Thoughts on PCS, PMA Skew Limits for 800 Gb/s Ethernet

Shawn Nicholl (AMD)

February 21, 2023
IEEE P802.3df Logic Ad Hoc

Contributors to Tx skew

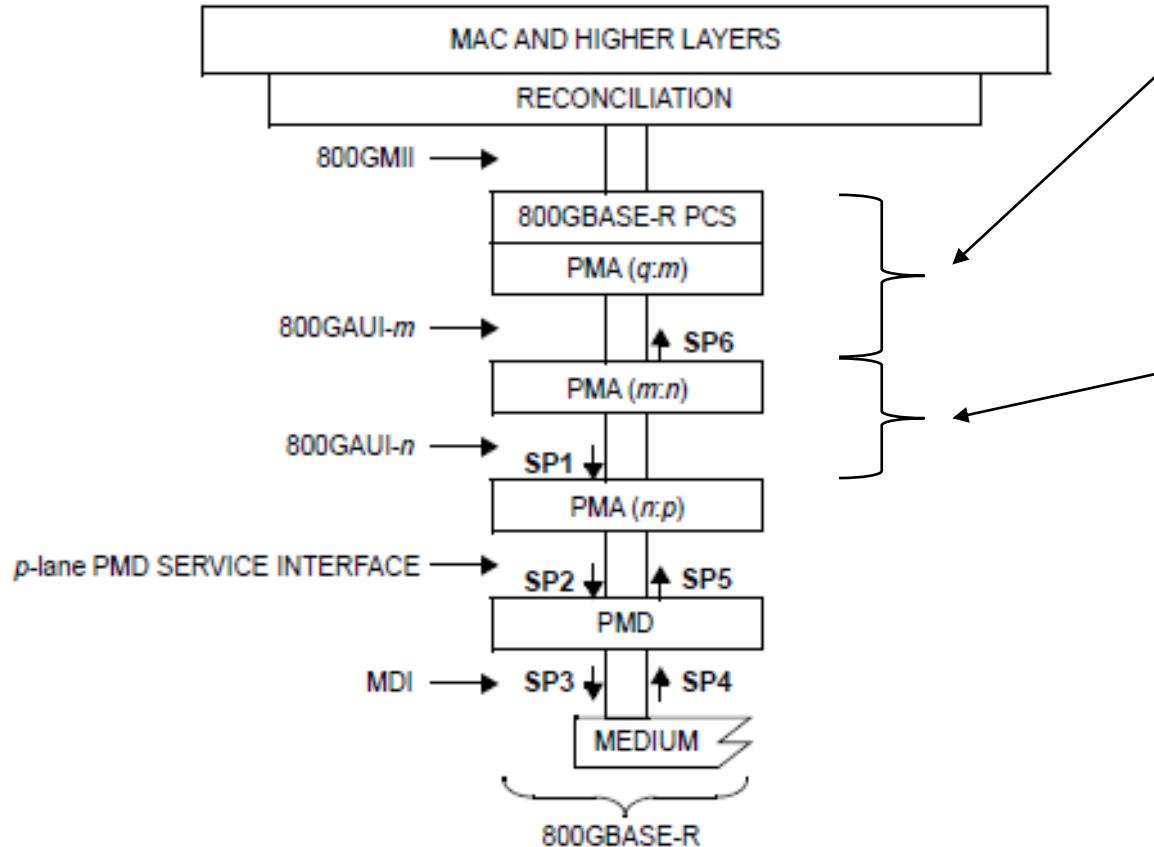
- **Tx PCS, FEC, PMA(q:m), and 800GAUI-m**
 - 2.4 ns (128 bits) due to FIFO fill difference
 - 2.4 ns (128 bits) due to serializer
 - Small amount of package Tx trace mismatch
 - 0.88 ns (board trace mismatch up to 4")
- **Tx PMA(m:n) and 800GAUI-n**
 - Small amount of package Rx trace mismatch
 - 2.4 ns (128 bits) due to deserializer
 - 2.4 ns (128 bits) due to FIFO fill difference
 - 2.4 ns (128 bits) due to serializer
 - Small amount of package Tx trace mismatch
 - 0.44 ns (board trace mismatch up to 2")
- **At SP1, estimate a maximum 13.32 ns of skew**
 - Propose 15 ns

Contributors to Rx skew

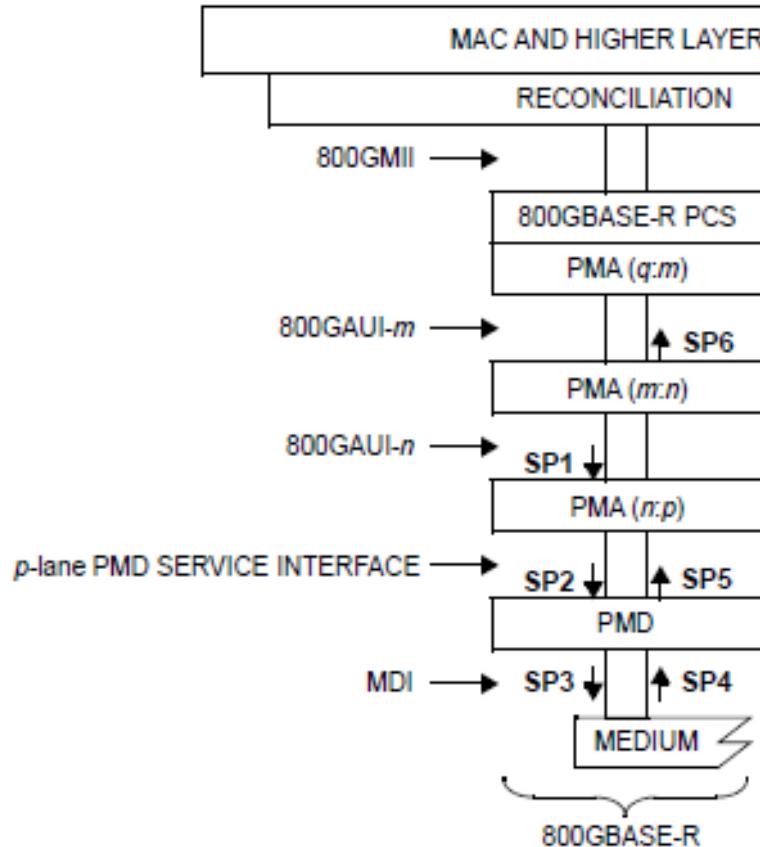
- **Rx 800GAUI-m, PMA(q:m), FEC, PCS**
 - 0.88 ns (board trace mismatch up to 4")
 - Small amount of package Rx trace mismatch
 - 2.4 ns (128 bits) due to FIFO fill difference
 - 2.4 ns (128 bits) due to deserializer
- **Rx 800GAUI-n, PMA(m:n)**
 - 0.44 ns (board trace mismatch up to 2")
 - Small amount of package Rx trace mismatch
 - 2.4 ns (128 bits) due to deserializer
 - 2.4 ns (128 bits) due to FIFO fill difference
 - 2.4 ns (128 bits) due to serializer
 - Small amount of package Tx trace mismatch
- **PMD service interface, PMA (n:p)**
 - Unquantified skew
- **Beyond SP6, estimate a maximum 5.68 ns of skew**
 - Propose 8 ns
